Denitex Limited.

9/1, Kornopara, Savar, Dhaka-1340
(23.823528, 90.256569)
22 March, 2016

Client Summary Report

Observations & Actions

Column layout showing areas to be evacuated.

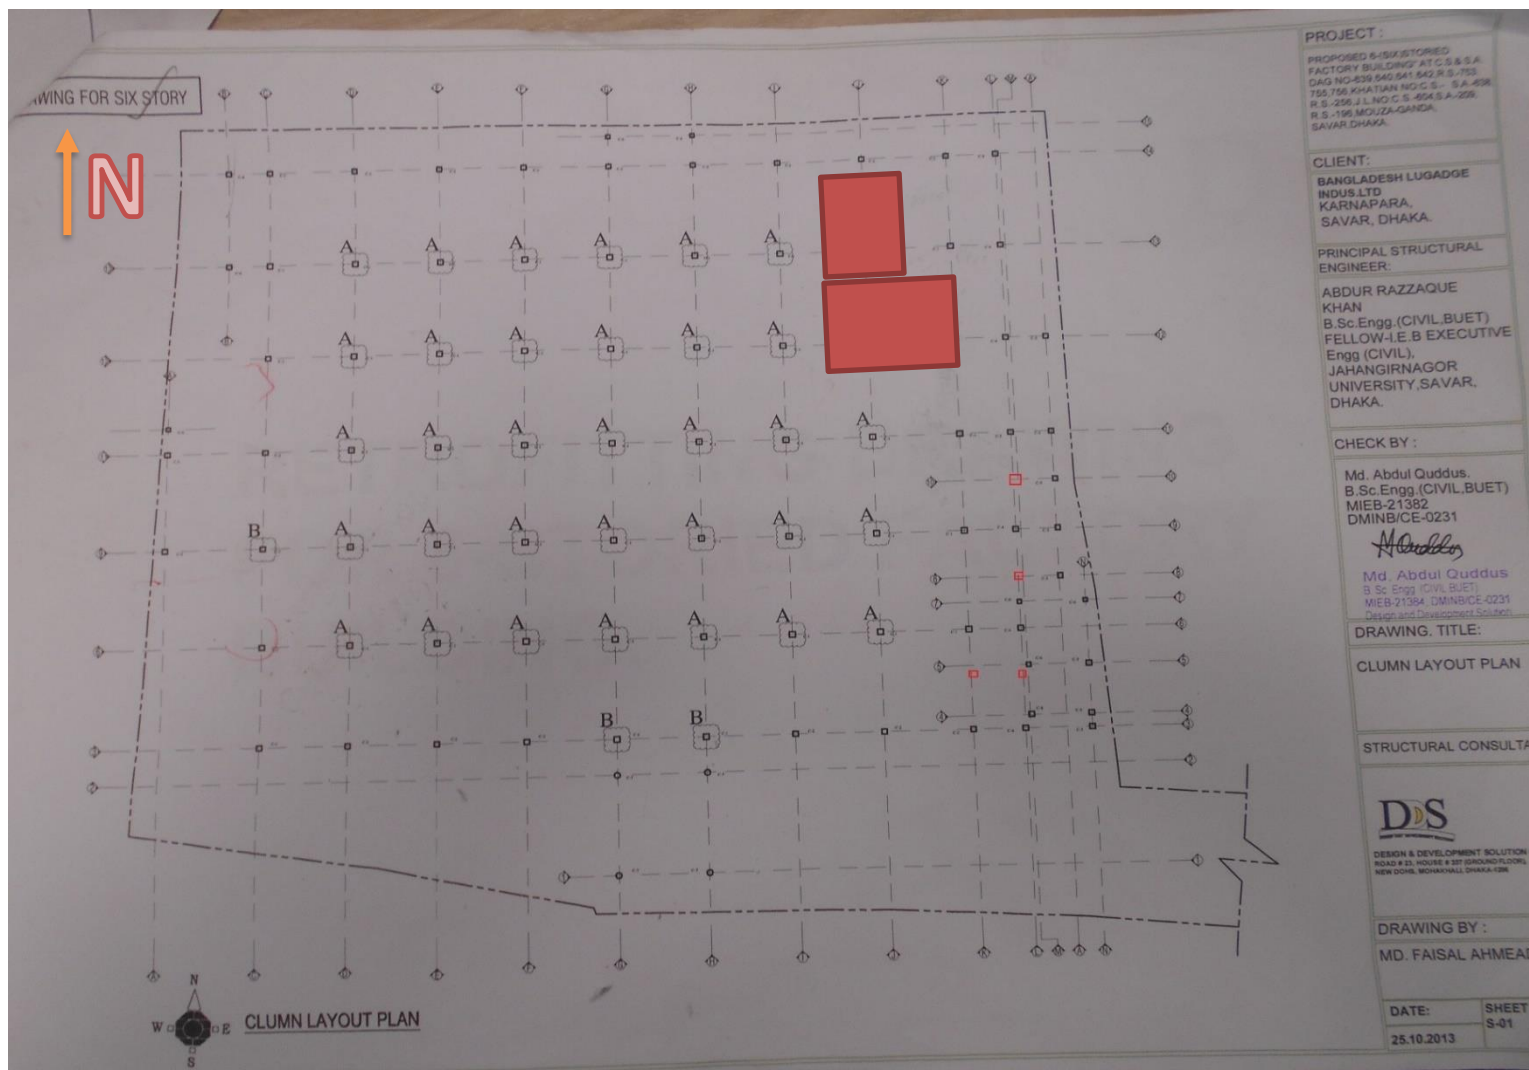
Building 1 : Factory Building. High stress on column

- No additional loads to be applied on area indicated in red on all floors
- Factory Engineer to review design, loads and columns stresses in area identified above.
- Verify insitu concrete stresses by 100mm diameter cores.
- A Detail Engineering Assessment of Factory to be commenced, see attached Scope
- No vertical or horizontal extension before completion of Detail Engineering Assessment.

- Produce and actively manage a loading plan for all floor plates within the factory giving consideration to floor capacity and column capacity.
- Building engineer to investigate the crack of the column.
- Detail Engineering Assessment to be completed

- Continue to implement load plan
